Silicon Anomaly List

ADSP-BF531/BF532/BF533

ABOUT ADSP-BF531/BF532/BF533 SILICON ANOMALIES

43. 05000471 - Boot Failure When SDRAM Control Signals Toggle Coming Out Of Reset:**DESCRIPTION:**

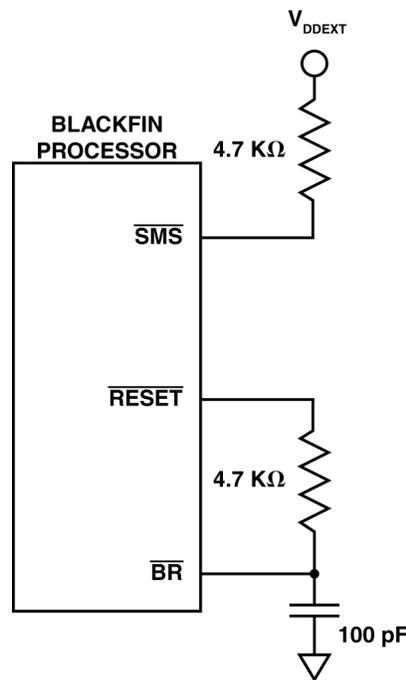
When $\overline{\text{RESET}}$ is de-asserted at the conclusion of the power-on reset sequence (not applicable to warm resets), there is a very small chance that the SDRAM control signals ($\overline{\text{SRAS}}$, $\overline{\text{SCAS}}$, $\overline{\text{SWE}}$, $\overline{\text{SMS}}$, $\overline{\text{SCKE}}$, and SA10) may be driven low for a single CLKOUT cycle. This activity can cause certain SDRAM devices to enter engineering test modes that result in the SDRAM driving data onto the shared EBIU data lines that the Blackfin processor is going to read from when configured to boot or execute from parallel flash.

When booting from parallel flash (BMODE = b#01), this contention corrupts the boot stream and causes the processor to hang. At this point, power-cycling the processor is required to clear the condition.

When executing from parallel flash (BMODE = b#00), this contention corrupts the op-codes and causes the processor to execute incorrect or illegal instructions, which may result in improper application execution or unexpected exceptions.

The delayed version of $\overline{\text{RESET}}$ seen on $\overline{\text{BR}}$ causes the Blackfin processor to continue to three-state the SDRAM control signals after the rising edge of $\overline{\text{RESET}}$ for longer than one CLKOUT cycle, which over-rides the glitch behavior described by this anomaly. The pull-up resistor on the $\overline{\text{SMS}}$ pin ensures that the memory-select signal remains de-asserted while the processor is three-stating the $\overline{\text{SMS}}$ output. Additional pull-ups are needed on the $\overline{\text{AMSx}}$ signals as well. This drawing contains the local connections to the Blackfin processor only. The $\overline{\text{RESET}}$ input pin is connected to the reset supervisor circuit, and the $\overline{\text{SMS}}$ output pin connects to the SDRAM memory select pin.
